## **Preliminary Staff Report**

### **Edgewater Redevelopment – 666 Wisconsin Avenue – Mansion Hill Local Historic District Request for Certificate of Appropriateness and Variance(s)**

**Madison Landmarks Commission - November 30, 2009**

**Photos of Buildings in the Visually Related Area:**

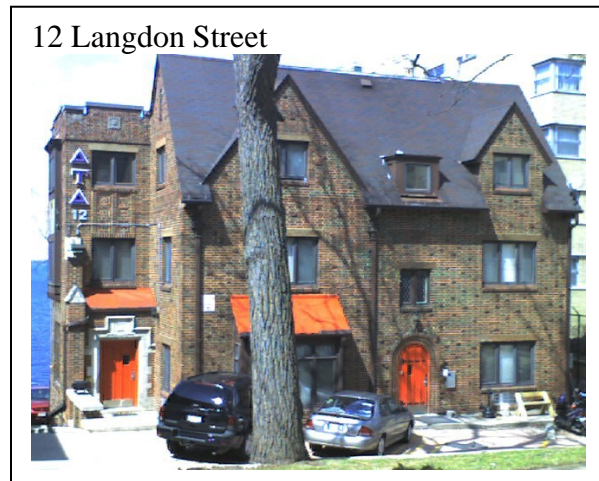
Several of the Mansion Hill Historic District criteria refer to buildings within the Visually Related Area. On the next page is a map of the Visually Related Area for this project, along with photos of each of the four buildings included within the area.

In this case, the development parcel (exclusive of the right-of-way proposed to be leased from the city) has a frontage at the end of Wisconsin Avenue (or ‘project north’ as shown on plans), and along the east side of Wisconsin Avenue (or ‘project east’ as shown on the plans). The Visually Related Area is a combination of 200-foot circles drawn from the center points of each of these segments.

Proportions between width and height for street elevations.

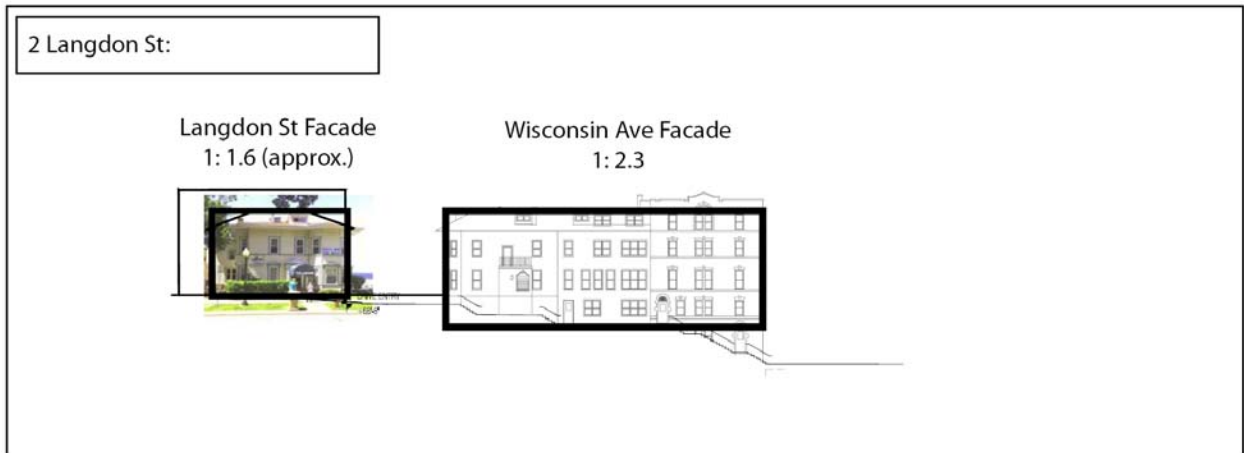
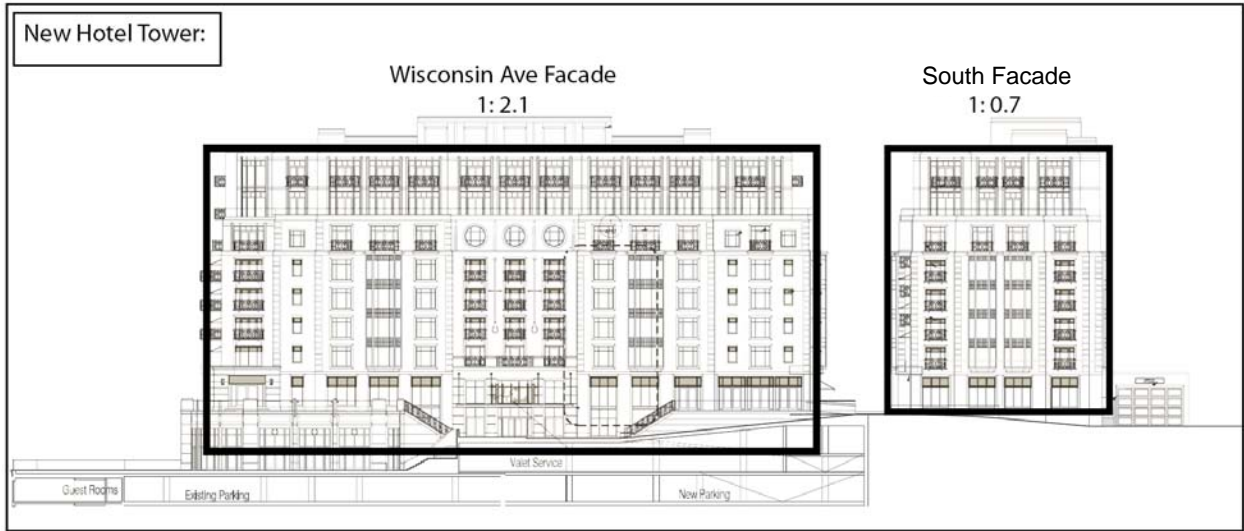
On the next page is a study that compares these elevations of the proposed new tower to the street elevations of other buildings within the visually related area. While the street elevation(s) are substantially larger than the street elevations of other buildings within the Visually Related Area, this criterion relates to “the proportion between the width and the height in the facades”, and based on the illustrations of the next page, these proportions appear to be similar.

Except for the photo of 2 Langdon Street, other information in the above graphic was taken from the application. Note that 10 Langdon Street was not included due to lack of scalable information, and 12 Langdon Street was not included as the building does not have a facade that directly abuts a street frontage.
